Owner Change Order (OCO)

Project Name: Brookline - Driscoll School
Gilbane Project No.: J08864.000

OCO: OCO-0015

Scope Of Changes: OCO 15 Misc. Changes

RFI #422

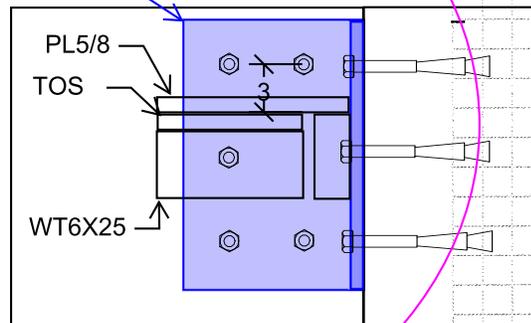
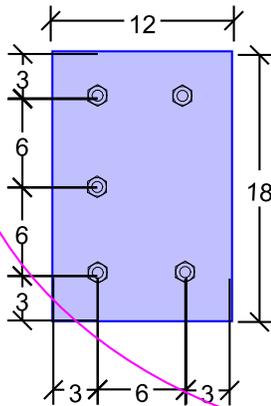
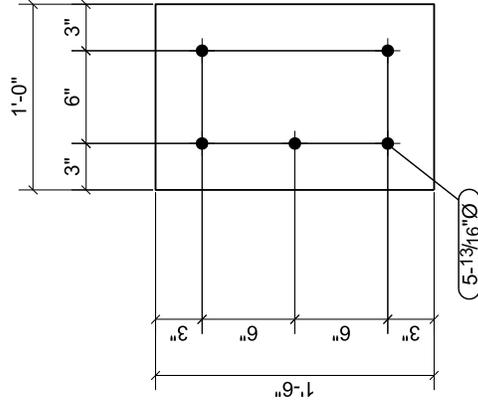
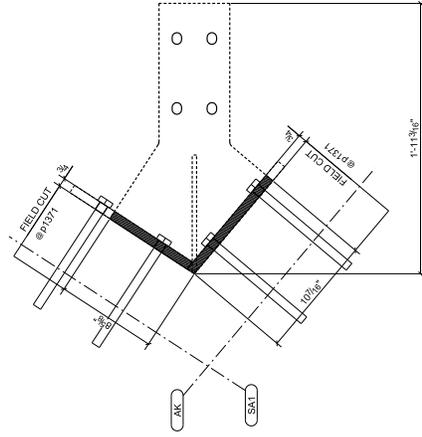
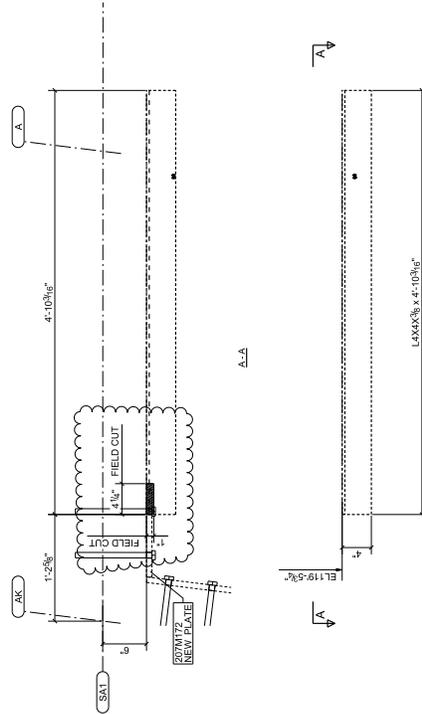
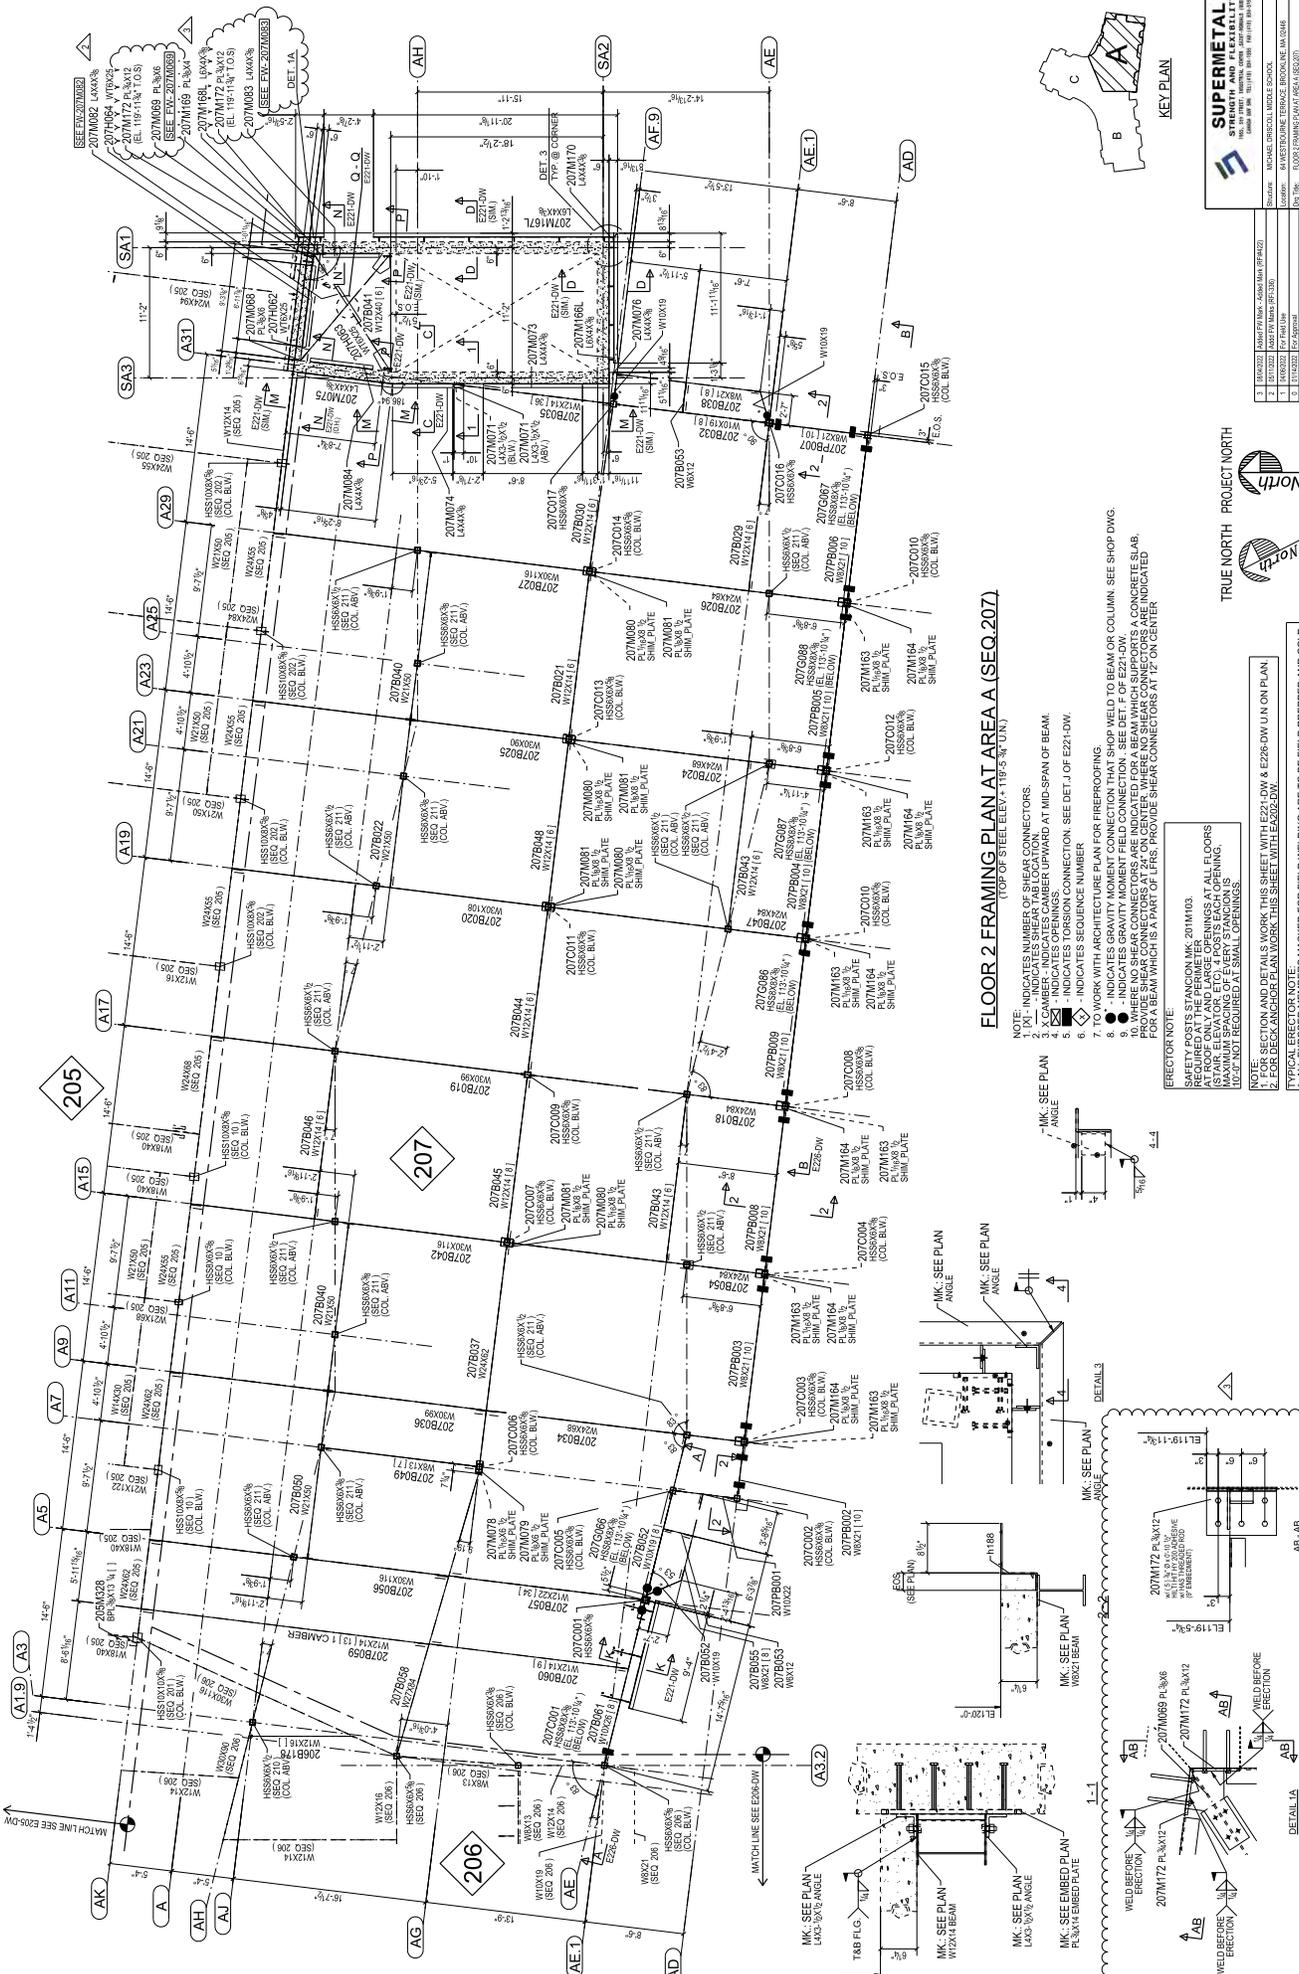
Please see attached marked up drawing highlighting the missed embed at the second floor landing at Core A. Also included in the attached document is the repair method used for the same missed embed at Stair C second floor landing, see RFI 348. Please confirm the repair is Field work solution is acceptable.

The response solution provided in RFI 348 is also acceptable in the Core A location shown on this document.
Susan K. Hulbert, P.E. LeM. 23 July 2022

Use RFI 348 response in this location.

FIELD WORKS:
 FIELD CUT THE ANGLE AS SHOWN CLOUDED
 TO SUIT THE NEW PLATE CONNECTION MK. 207M117Z.

BOX DRAIN DETAIL
 SCALE: 6" = 1'-0"

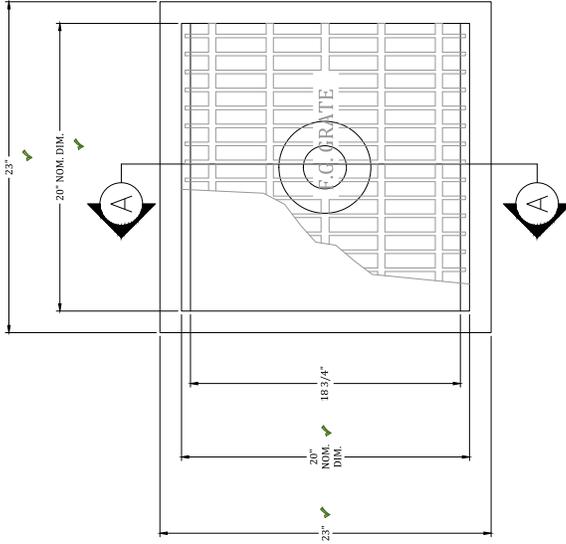
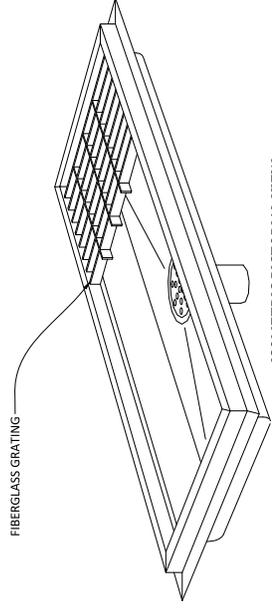
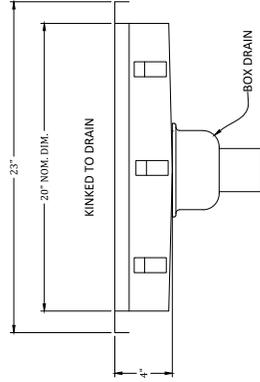
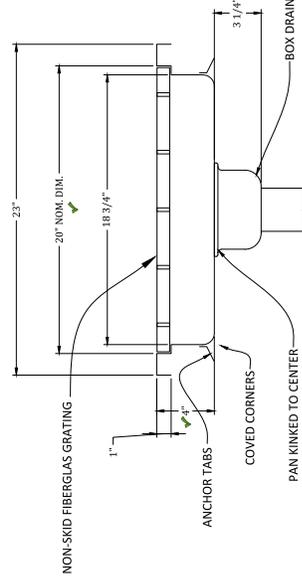
There is kitchen floor slab opening shown on structural drawing S101A vs. a floor depression on Food Service drawing FS101 near col. lines AN & A14. The kitchen floor pan drain (food service item #29) is located and dimensioned on drawing FS-131A. Attached see the floor pan product information from Submittal #11 40 00 -2.6.4. The floor pan size is indicated as (20" x 20" x 4") with outside edges at (23" x 23"x 4"). The Plumbing has been coordinated to the dimensions shown on FS-131A. Sequence 201 Steel shop drawings (05 12 00-026) were submitted with the slab opening as shown on drawing S101A. The steel shops was returned with a note - "DEPRESSED SLAB EL. 105'-9".

Please provide structural design detail on how to support the metal deck for this depression with all dimensions required.

Refer to following comments noted in green on sheet E201-DW, which locate the slab opening and centerlines of steel at slab depression. James Machek JLA 01/22/2022

1 FRAMING PLAN - FLOOR 1 - C
SCALE: 1/8" = 1'-0"

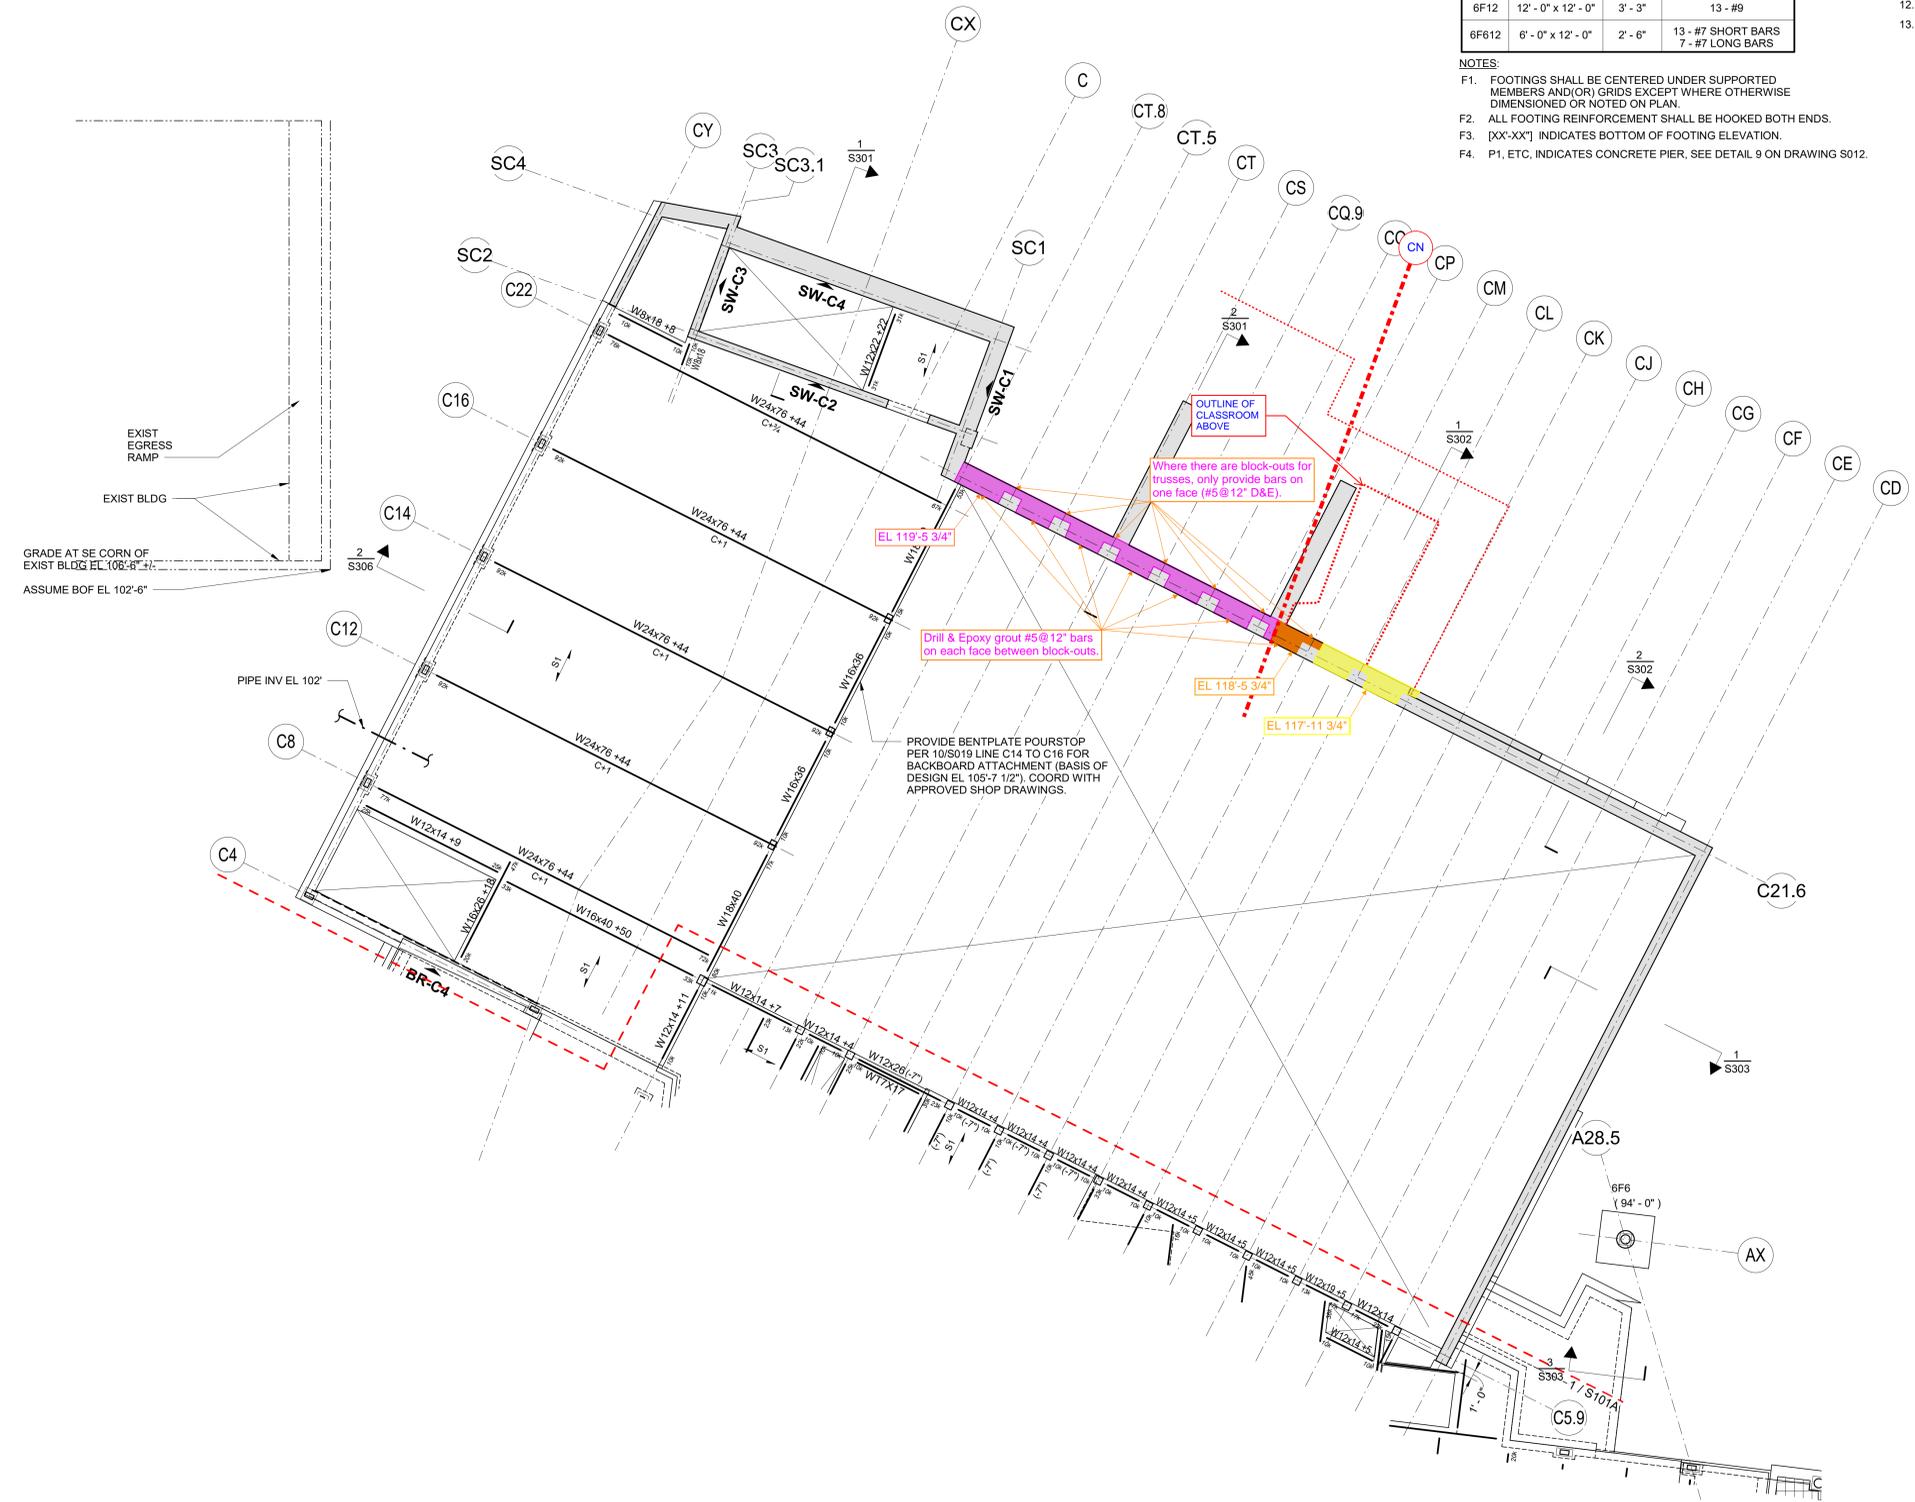
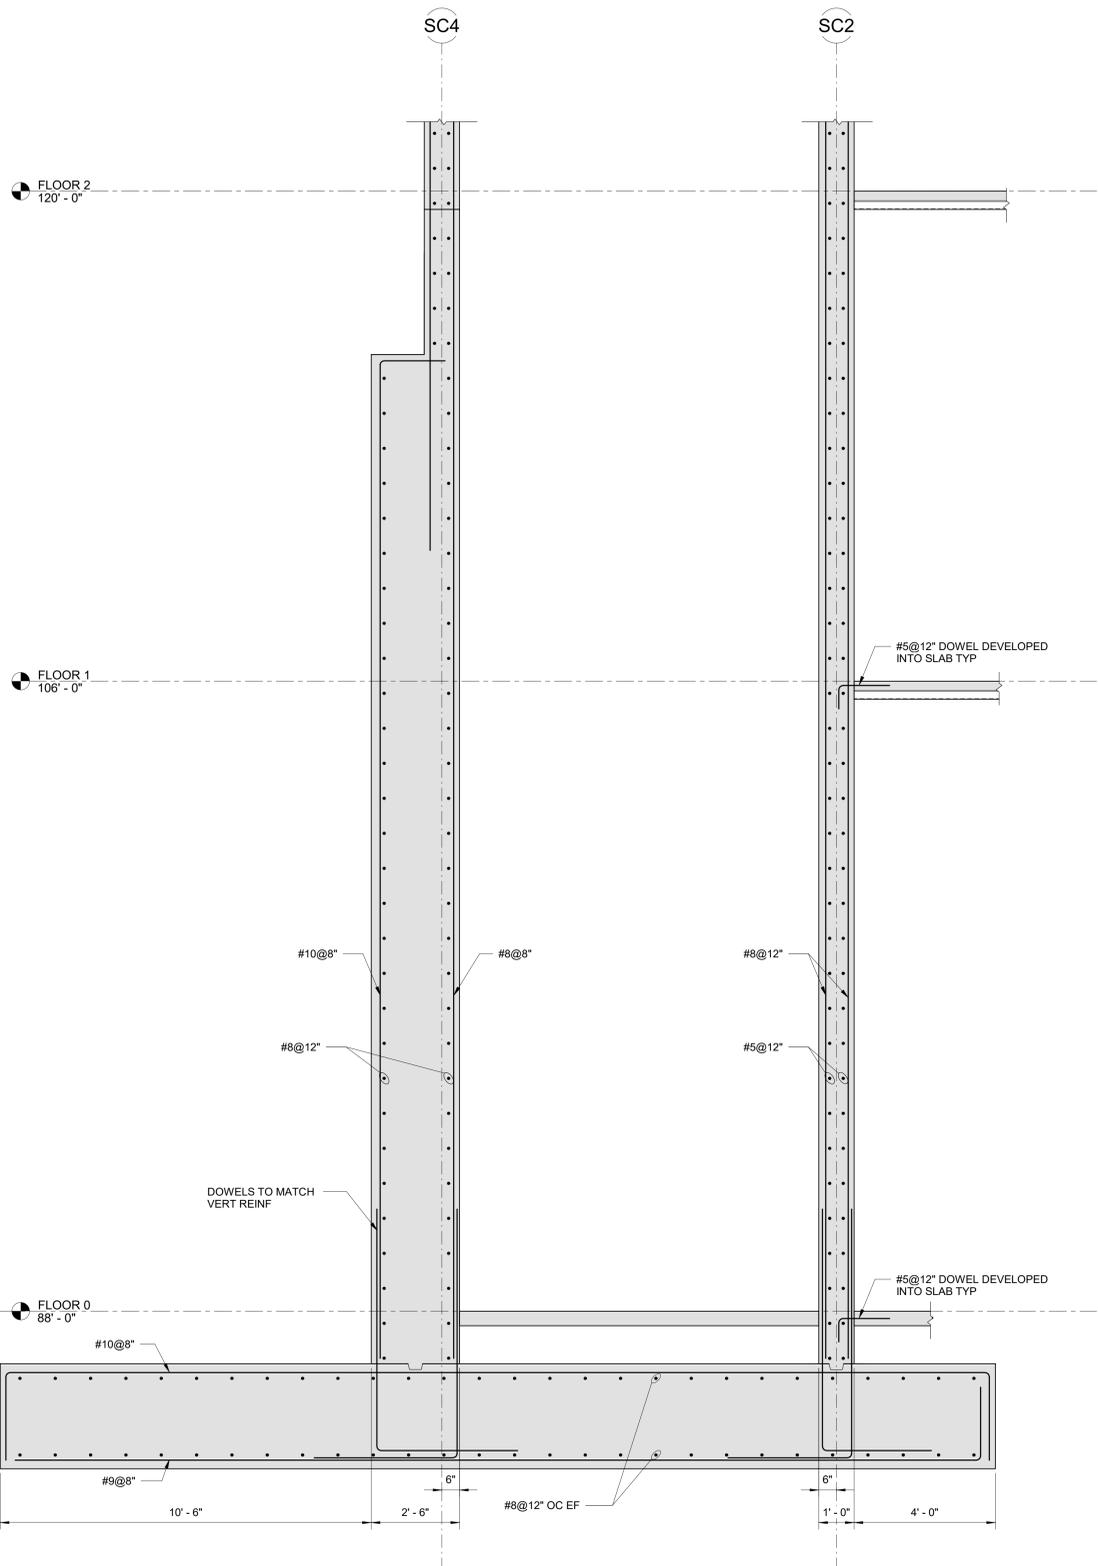
Please see attached marked up drawings regarding the foundation wall along C21.6 Line. Per Detail 2/S301, and the approved shop drawings, the top of wall at CT.8 and CM at C21.6 was poured at elevation 118' 0". Per further review between GBCo and LeMessurier, the wall should have been poured at Elevation 119' 5 3/4". Please Confirm. also, per further review of the rebar shops, that top of wall between CM and CK at C21.6 should be at elevation 117' 11 3/4", rather than at elevation 120' 0" as shown on the approved rebar shops. Please confirm the top of wall elevations as noted. Due to the wall being poured 17 3/4" too per the approved shops, please provide a detail for adding a curb to the top of the wall. Please provide spacing, embed depth, and rebar size to bring the wall up to the correct elevation (119' 5 3/4")

See attached for LeMessurier response in magenta and orange.
